PLANNING BOARD REPORT PORTLAND, MAINE

749 Congress Street
Subdivision Plan and Level III Site Plan
Project ID #2016-040
Denovo, LLC, Applicant

Submitted to: Portland Planning Board Public Hearing Date: July 12, 2016	Prepared by: Shukria Wiar, Planner Date: July 8, 2016
---	--

TO: Shukria Wiar, Planner
FROM: Lauren Swett, PE
DATE: July 8, 2016
RE: 749 Congress Street, Site Plan Application
Peer Review & DPW Review

GRADING & UTILITIES PLAN

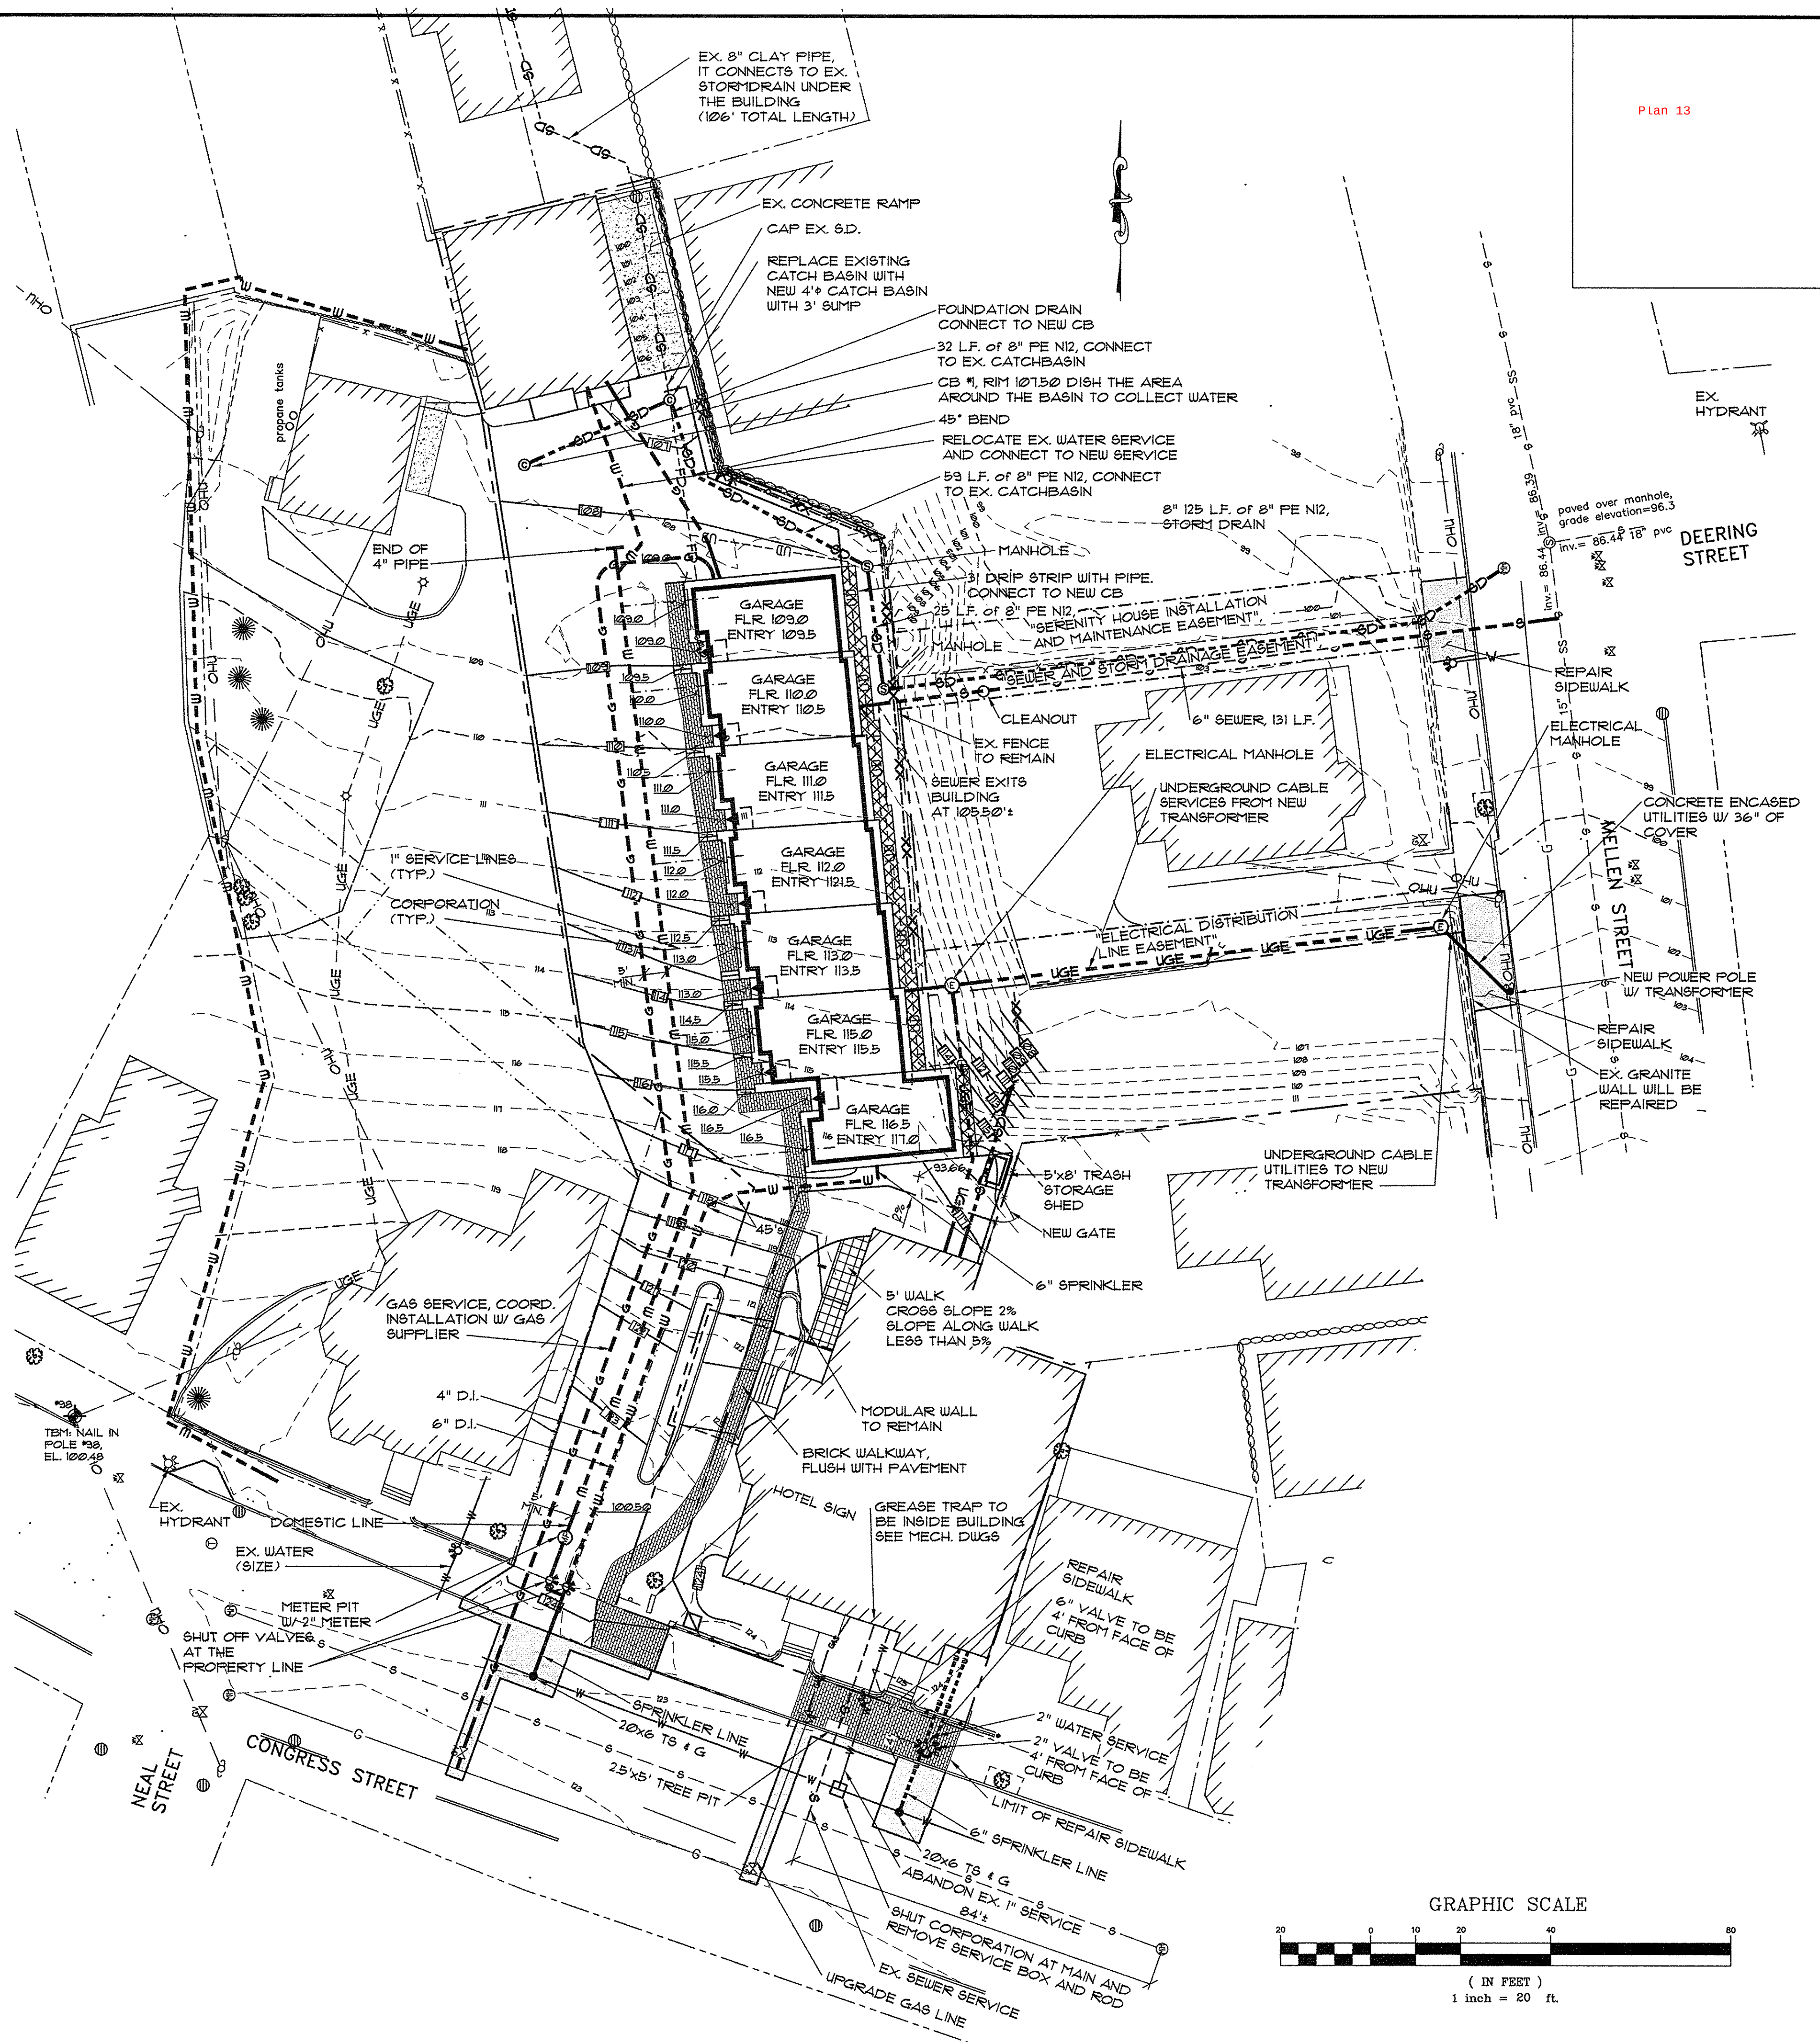
6. Adequate stabilization (i.e. rip rap) shall be provided at the end of stormdrain pipe at the northern end of the hotel building; and
 7. The driveway apron on Congress Street shall be in brick. The Applicant shall modify the plan and provide a detail for brick driveway apron in conformance with the technical standards, prior to the issuance of a building permit; and

- 3) The Applicant is providing a 1,000 gallon internal grease trap. The Applicant shall contact Rachel Smith (874-8833) of the Public Works Department prior to installation to verify property sizing.
- 4) The Plat has not been stamped by a Professional Land Surveyor as required.
- 5) There are instances of text conflicting with hatch patterns. When the Registry of Deeds scans the plans for public viewing via the internet often the text is not legible due to the conflicts with the hatch patterns.
- 6) All other prior Department of Public Works Comments have been addressed.

5 BITUMINOUS DRIVEWAY APRON (I-13)
NOT TO SCALE

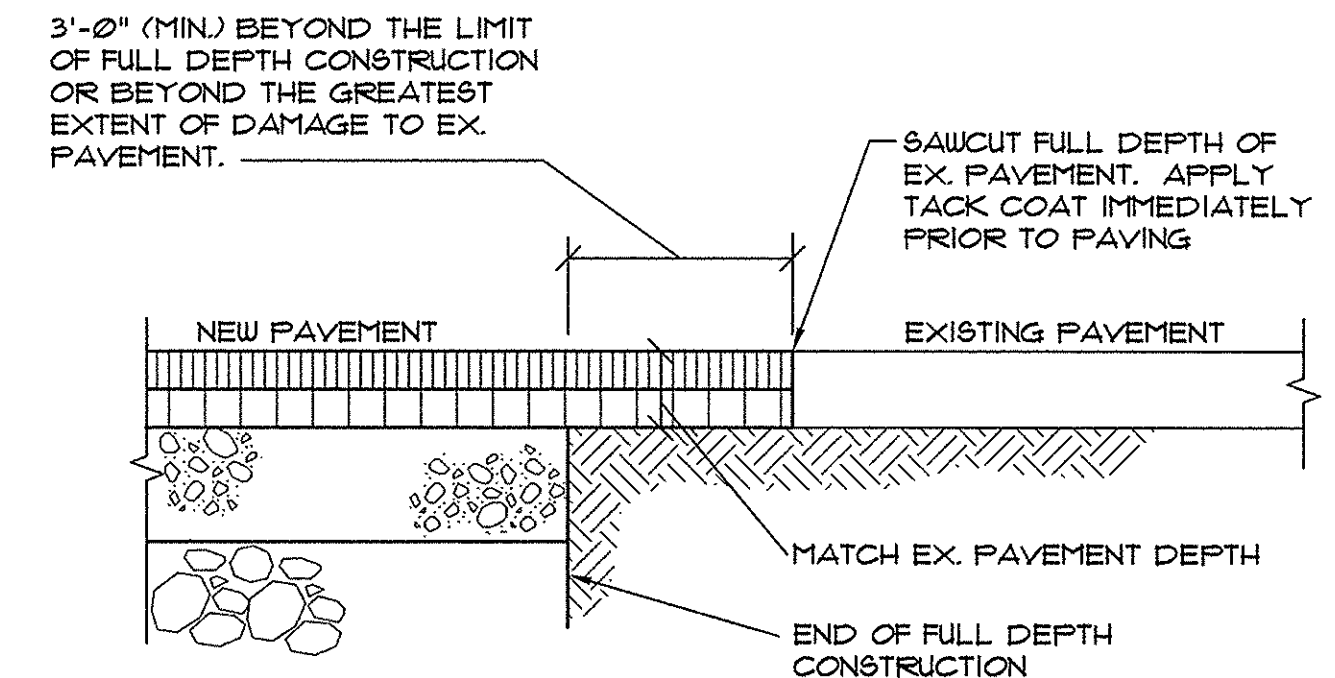
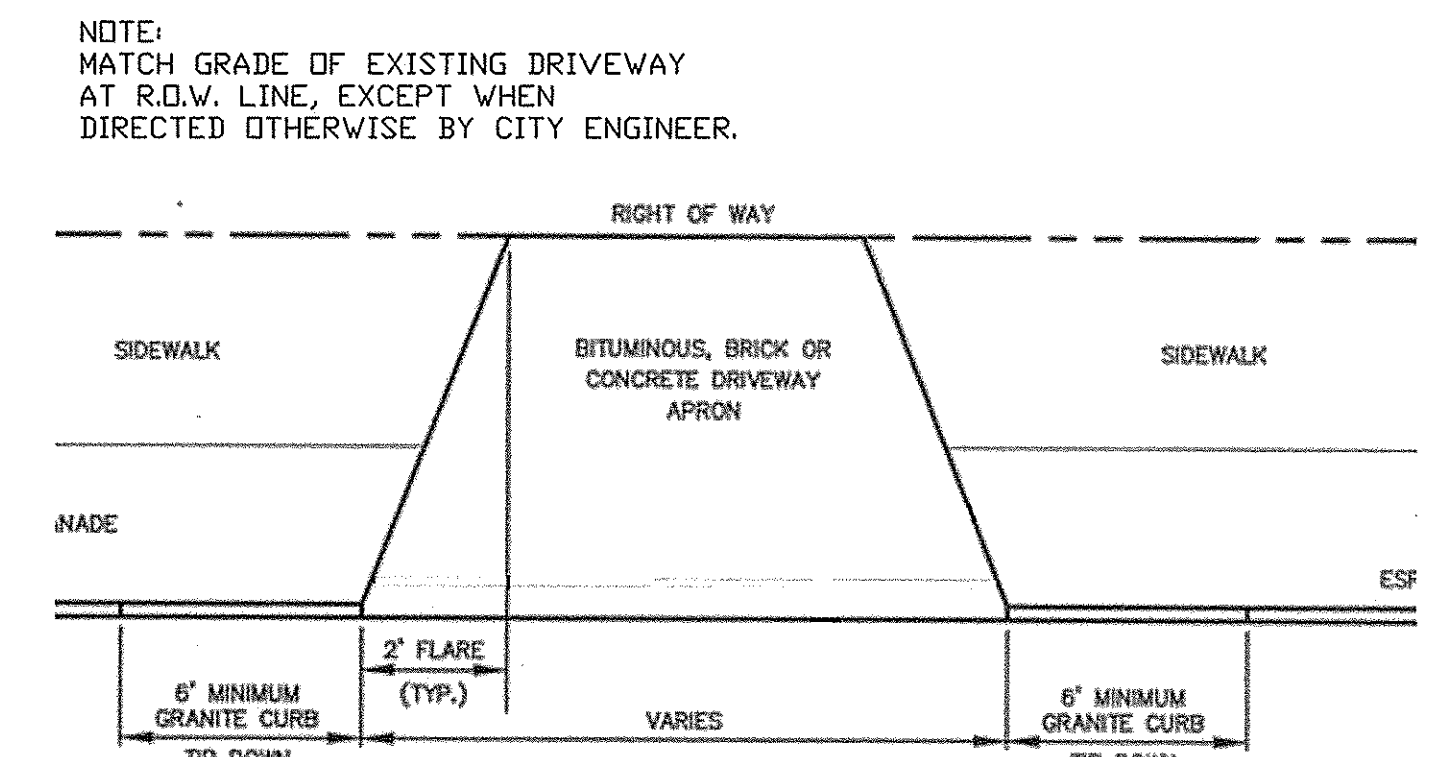
- 1) The project is located within a Historic District, and a brick driveway apron will be required. The Applicant should modify the plan and provide a detail for brick driveway apron in conformance with City of Portland Technical Standards.
- 2) The utility work in Mellen Street must be completed by December 1, 2016. The City of Portland will complete final milling and overlay of Mellen Street in the spring of 2017.
